MANAGER'S MEMO ITEM

ITEM: PLAN COMMISSION FILE NO. 10-05; Gronych's Walnut Grove Subdivision, Rezoning and Final Plat with Exceptions

PLANNING & COMMUNITY DEVELOPMENT STAFF REPORT

TO: Amanda Riordan, Planning & Community Development
FROM: David H. Barber, P.E., Director of Public Works
BY: Michael D. Millette, P.E., Asst. Director of Public Works – Engineering
Jonathan C. Hall, P.E., Development Engineer *JH*
DATE: March 11, 2005
RE: Planning / Zoning Request
Proposed subdivision – Gronych's Walnut Grove south of 66th Street between
Briargate and St. James Court
Public Works Department - 3rd Review

GENESIS JOB NO.
04-430
 SHEET 6 OF 7

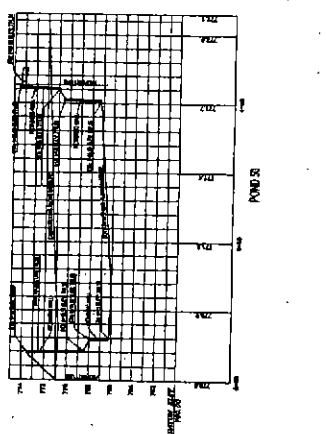
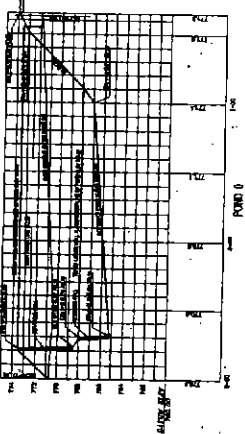
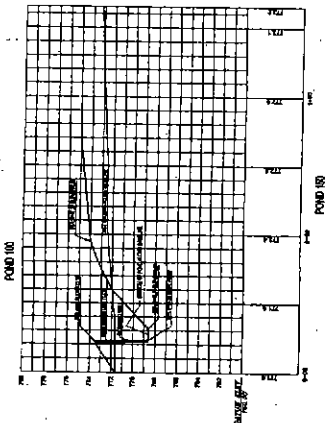
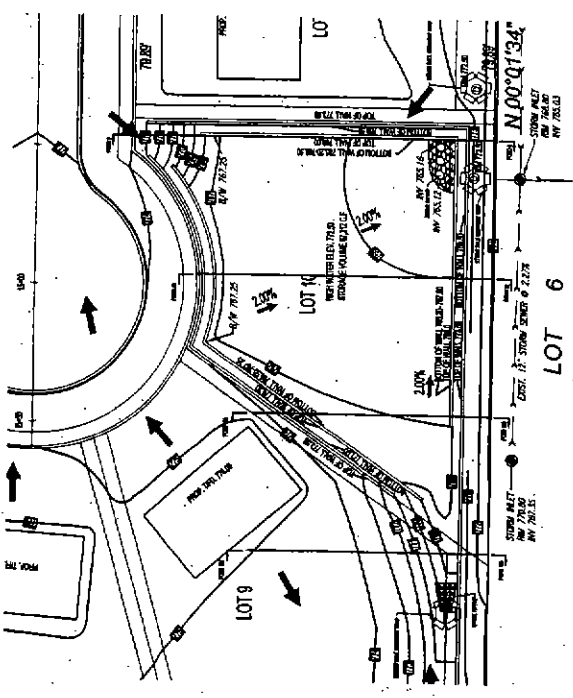
6. The freeboard elevation of 773.5 feet is not closed off north and south of the pond and extends into Lots 9 and 11. This should be revised or additional drainage easements should be shown for these areas on Sheet 6 of the plan set.
Accepted. Please add a drainage easement over the 722.5 contour between lots 2 and 3 along the western property boundary.
